MODEL
Sorento (XM) 2.4L
GDI 2013MY

NUMBER
126 [Rev 1, 12/11/12]

TECHNICAL SERVICE BULLETIN

SUBJECT: ALTERNATOR PULLEY AND TENSIONER REPLACEMENT

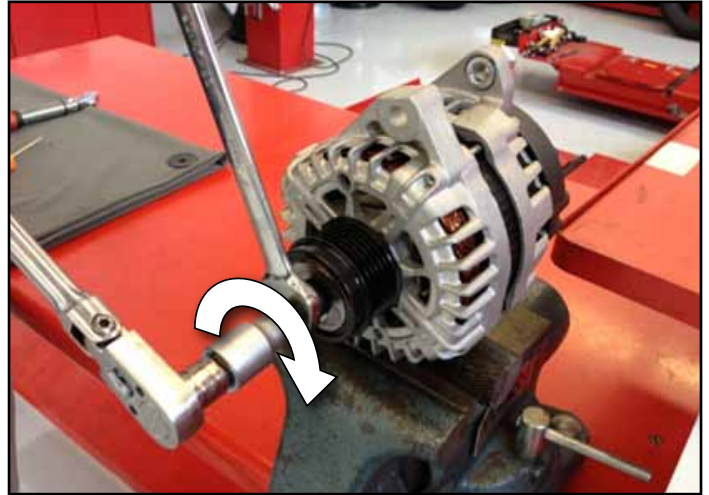
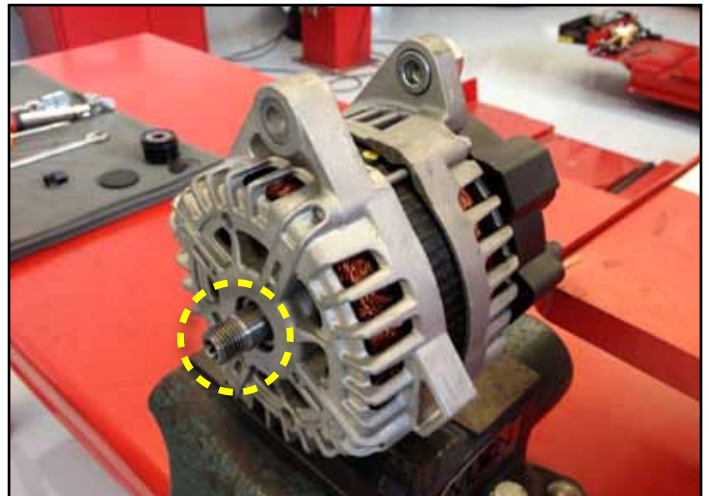
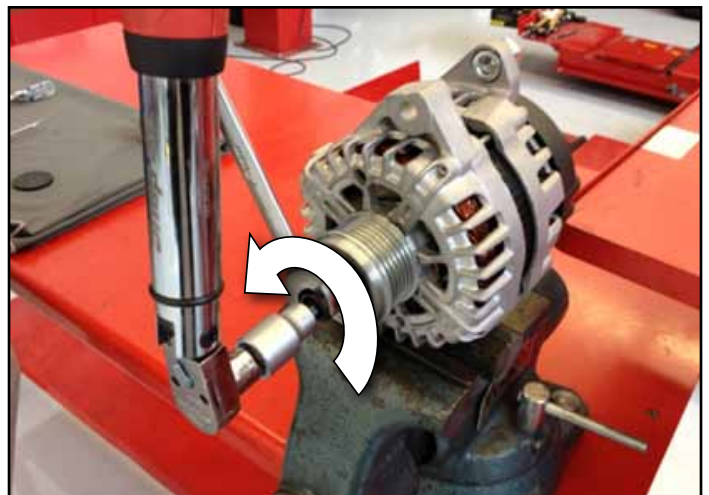
9. Use a wrench to hold the pulley removal/ installation tool and rotate the Torx® socket **clockwise** to loosen the pulley.

10. Remove the pulley from the alternator.

11. Install new OAP pulley onto the alternator shaft by hand. Using a wrench, pulley removal/installation tool and Torx® socket, secure the OAP pulley to the shaft by turning the socket **counter-clockwise**.

Tightening torque: 50 lb-ft (67Nm)
